Equipment Technical Bulletin

200 RPM Big Wheel Pump Motor Change

Figure 1. New Pump Motor Gearbox

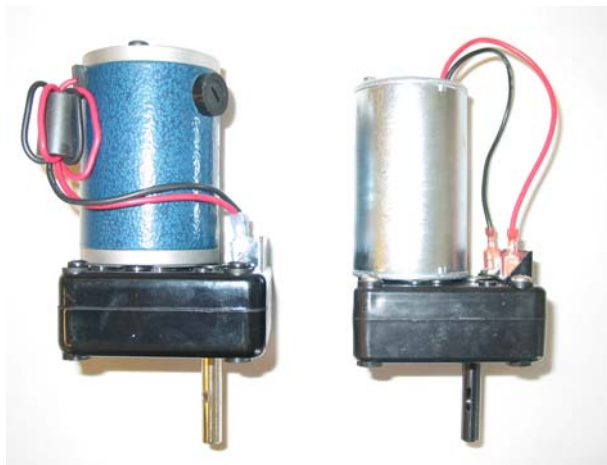
Due to the inconsistent quality of the 200 RPM big wheel pump motor used in ILS, ILS Max, and PR1100, we have identified a new supplier for this part. For details on the pump motor quality issue, see ETB "Premature Motor Failure in ILS, ILS Max, ILS MaxT Summit XL and P-6100T", #15072-00, November, 2003. Please contact Customer Service if you need a copy of this ETB.

- The new big wheel pump is of slightly larger diameter and weighs about 10% more. These differences will not affect the way the motor operates with Beta dispensers.
- The new motors will fit into all equipment that currently use 200 RPM motors.
- The new motor will last twice as long as the old motor
- The catalog number for the new pump motor is #038835.
